16 July 2023

Reading Conservation Commission
16 Lowell Street
Reading, MA 01867

RE: 31 Wilson Street, Reading MA – Notice of Intent
Response to 7/12/2023 Hearing requests

PERMEABLE PAVER - FULL INFILTRATION TO SOIL SUBGRADE

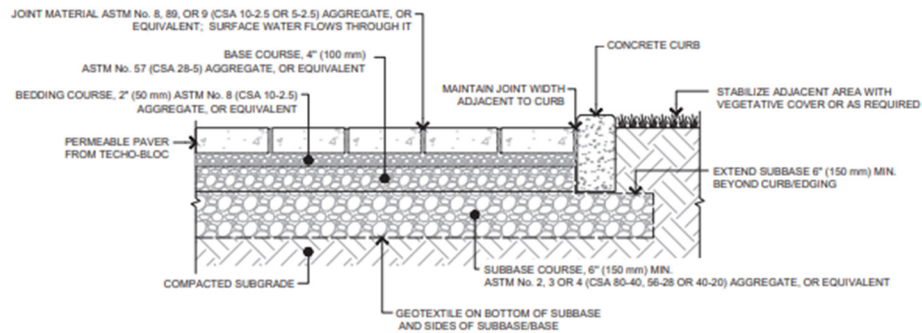
In response to 7/12/23 conservation committee hearing request for more information regarding paver patio, please find additional information including patio dimensions and clarified paver substrate cut detail:

The patio dimensions, as depicted on the Proposed Plot Plan submitted with original NOI application, are 24’-5” x 10’-6”. Patio will be a blend of permeable pavers and Turfstone grid style pavers. Permeable paver inlay area will be 14’-0 x 6’-0, remaining area will be Turfstone grid style pavers with grass infill. See Schematic Landscape Plan (SK-03 Revised) for illustration of paver type zones.

Substrate Cut Section detail (per manufacturer’s recommendations)
